SERVICE BULLETIN

M-1025

May 26, 1992

BATTERY CASES

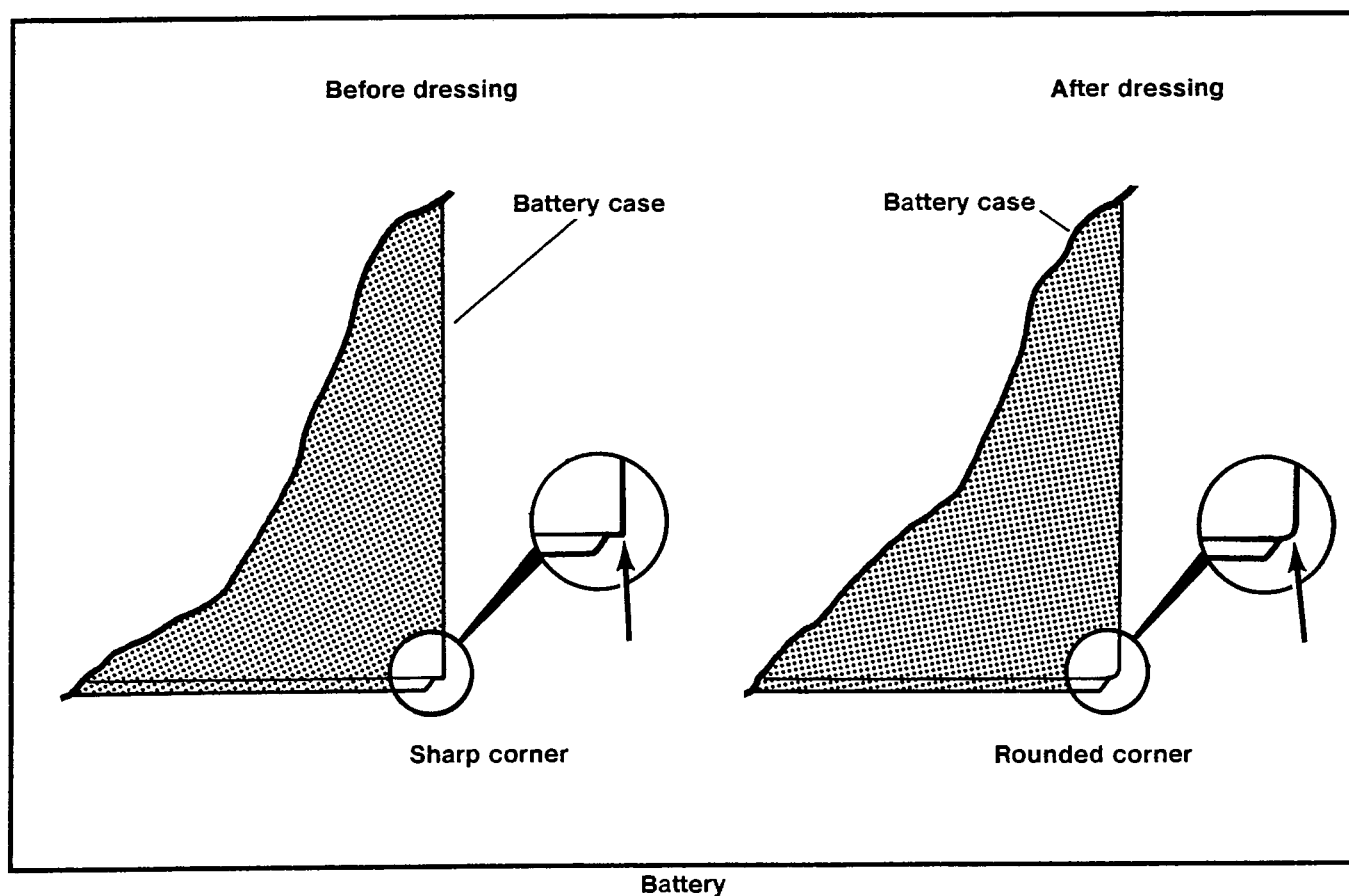
Yuasa has changed their molds to eliminate the sharp bottom edges of their battery cases.

See illustration. Until the new batteries are available, Harley-Davidson suggests that whenever an original equipment or Parts and Accessories battery is removed or replaced for any reason, the sharp bottom edge be

dressed. Use a medium emery paper.

Do not remove battery case material other than at the sharp edge. If material other than the edge is removed, it is possible the battery case could leak fluid.
